ADDENDUM NO. 1

ROWE
Federal Aid Project No. STP(BR-OFF)-003S(739)X
Superstructure Replacement, R-10-008, Cyrus Stage Road over Potter Brook

ROWE
Federal Aid Project No. STP(BR-OFF)-003S(739)X
Superstructure Replacement, R-10-008, Cyrus Stage Road over Potter Brook
(Proposal No. 608855-126249)

Questions and Responses

WEST ABUTMENT AND WALLS

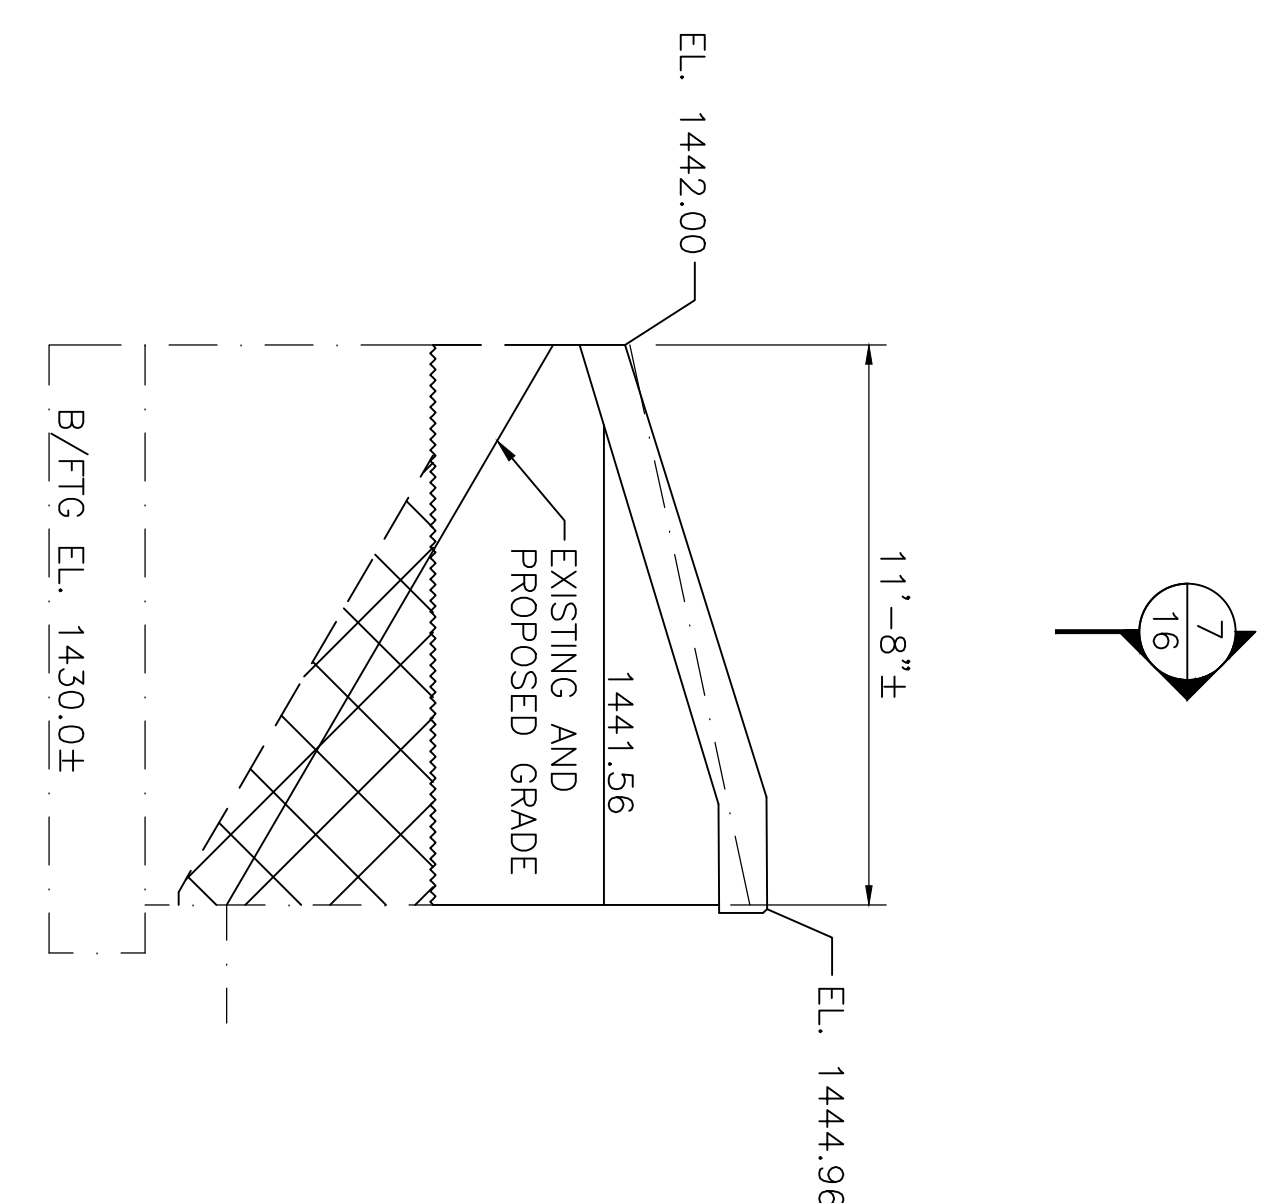
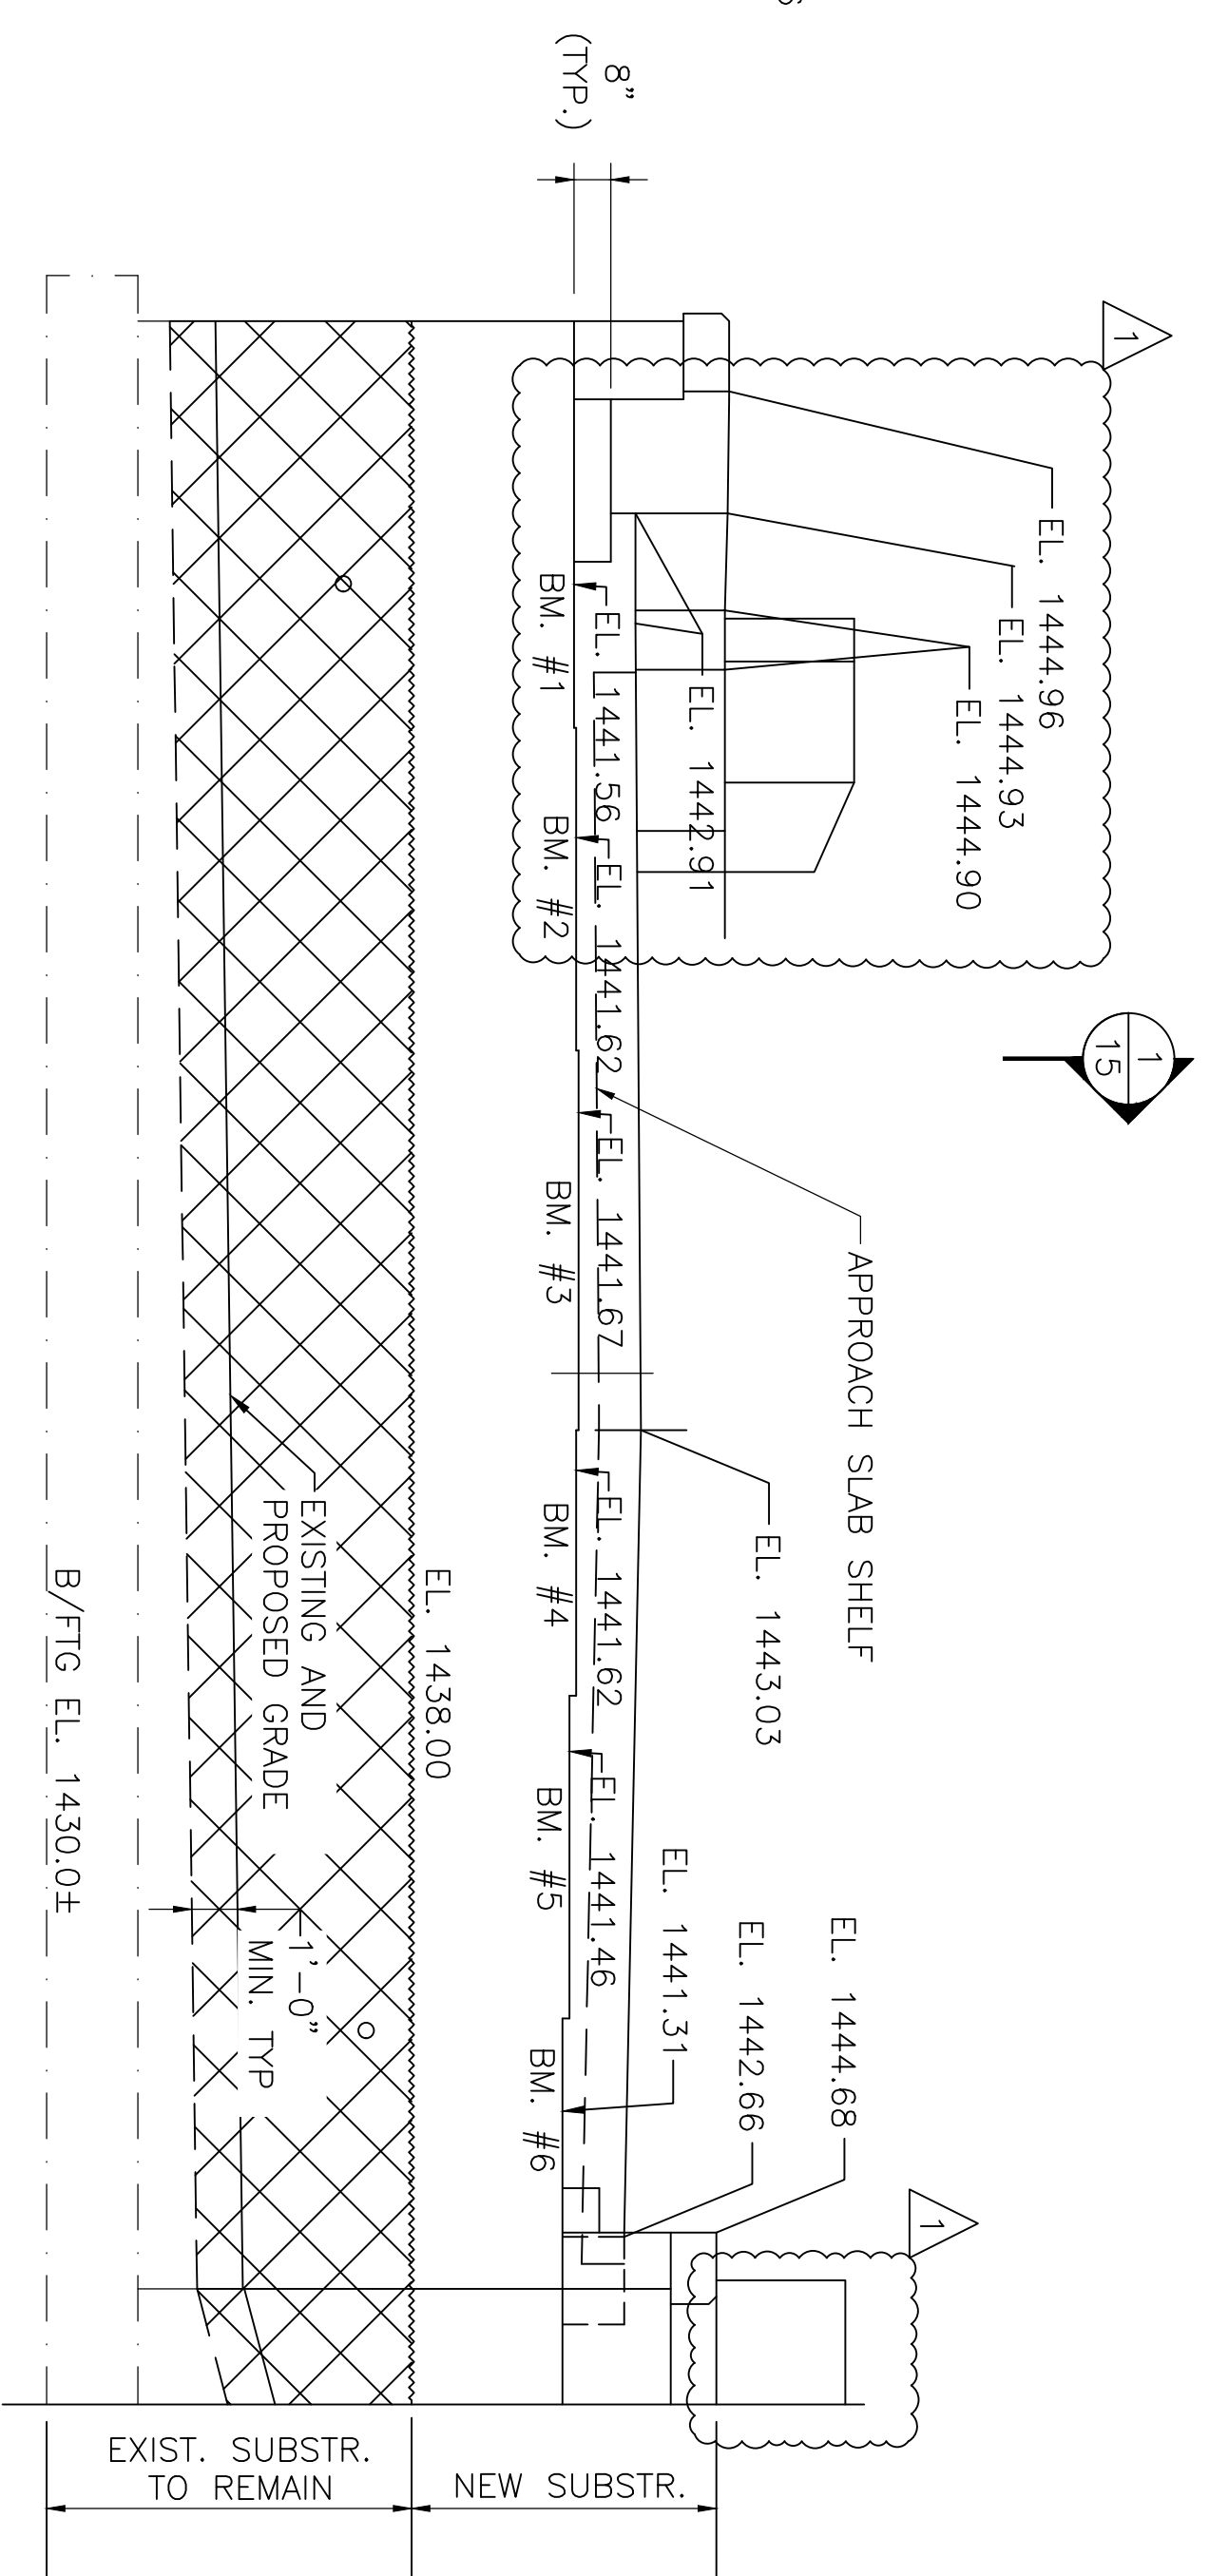
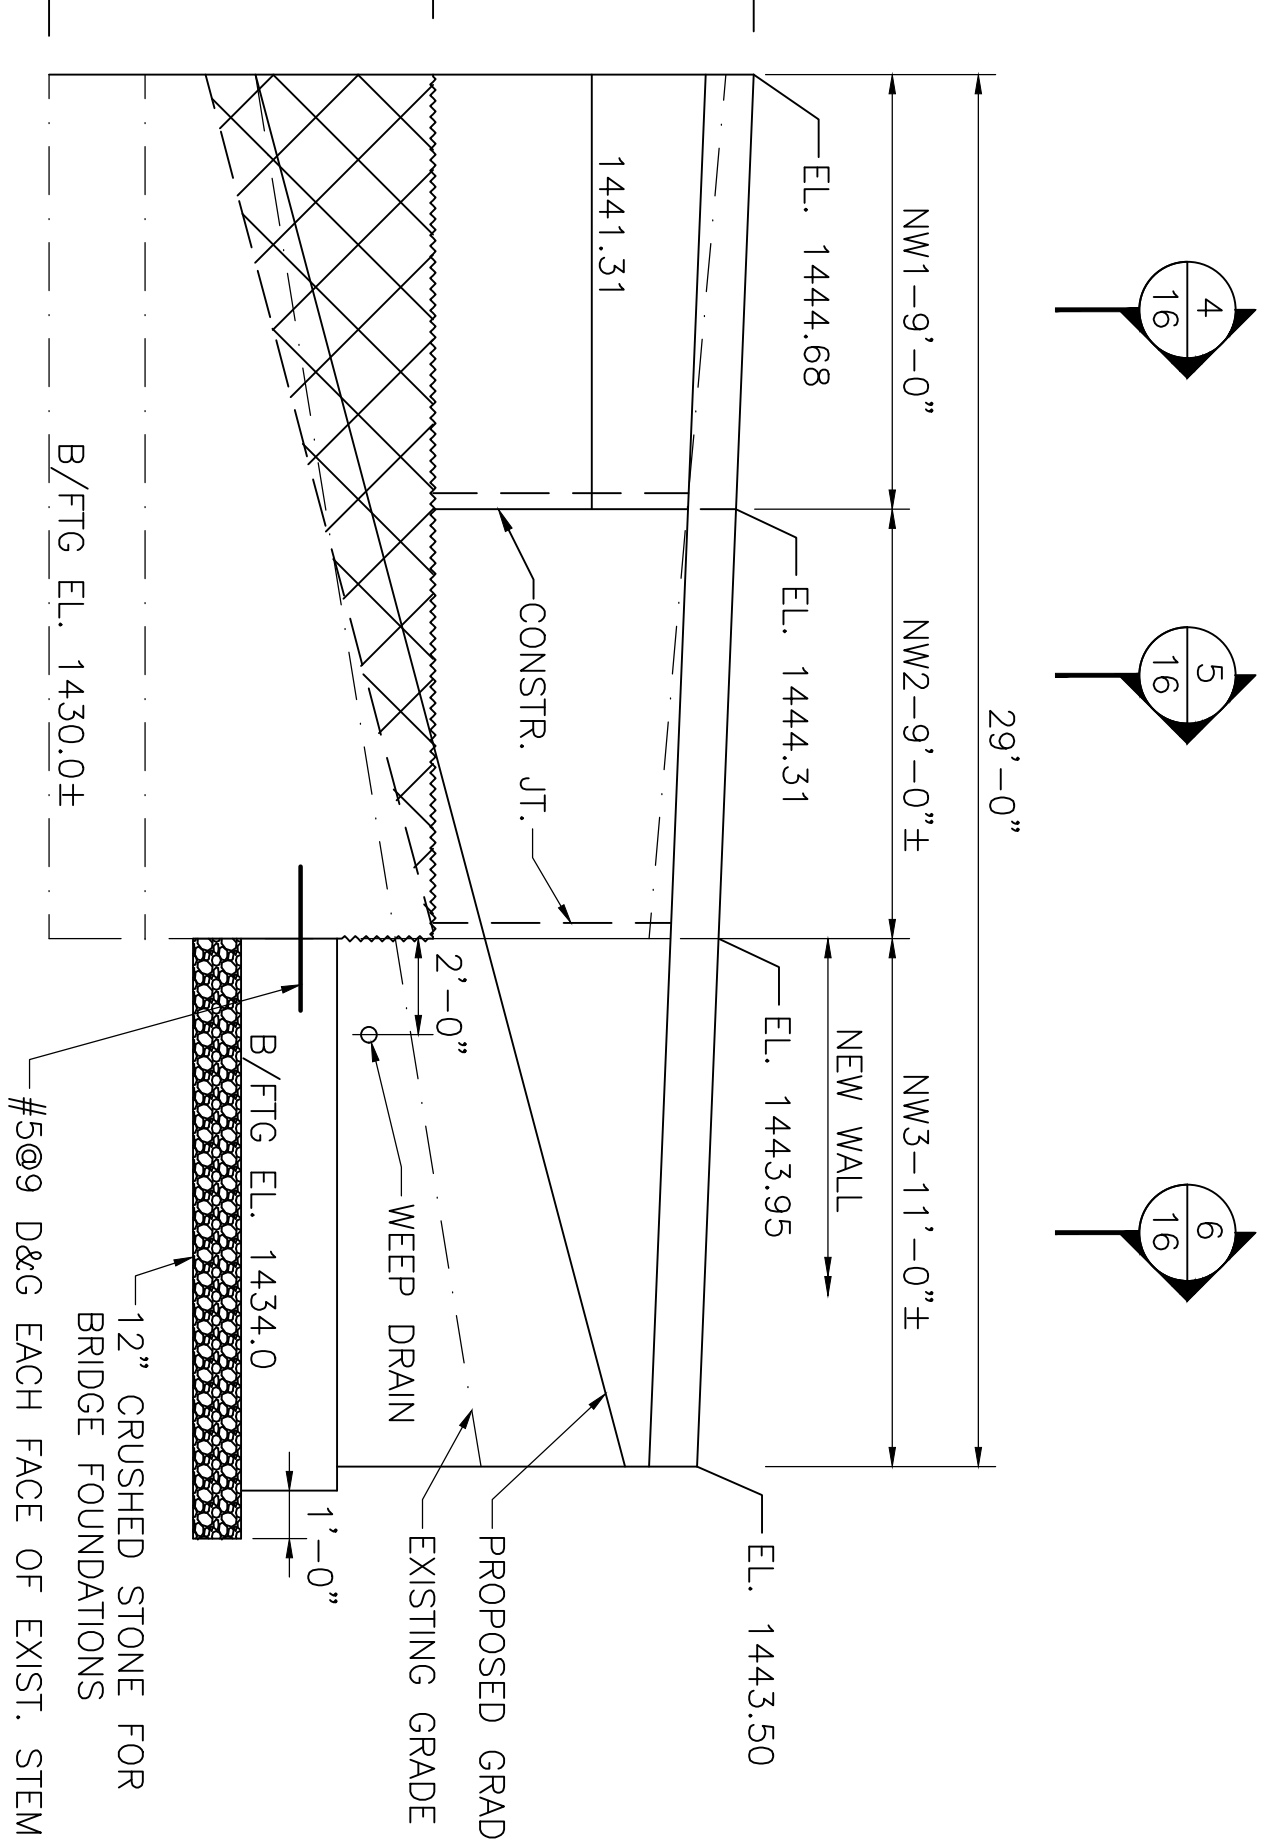
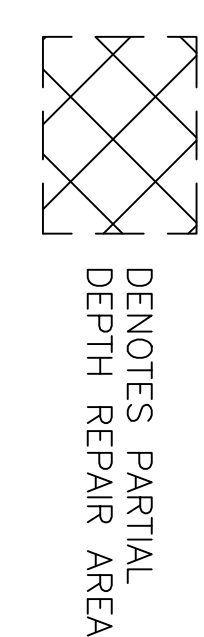
Question 3) Please refer to sheet 13 of 25 of the bridge drawings. It appears that the proposed precast highway guardrail transitions are going to conflict with the existing abutment sections that are to remain. Please provide additional details regarding these proposed guardrail transitions and how they will tie-in to the existing abutment.

- Question 4) Please refer to sheet 23 of 25 of the bridge drawings, detail: “Precast Guardrail Transition Plan at NW, SW, and NE Corners.” It doesn’t appear that this detail matches the curtain wall layouts shown on the abutment drawings, particularly on the SW and NE Corners. At the SW and NE Corners, it appears the curtain walls extend beyond the limits of the existing abutment at the demolition limit. Please clarify and provide further details on these curtain walls.
- Response 4) See revised Plan Set Sheets Nos. 29, 30, and 31 of 50.

Response 3) See revised Plan Set Sheets Nos. 29, 30, and 31 of 50.

DATE	DESCRIPTION
7/10/2024	PLAN AND ELEVATION REVISED
6/8/2024	ISSUED FOR CONSTRUCTION
THIS SHEET IS APPROVED FOR CONSTRUCTION BY MASSDOT STATE BRIDGE ENGINEER AUTHORIZED SIGNATORY: _____	
USE ONLY PRINTS OF LATEST DATE
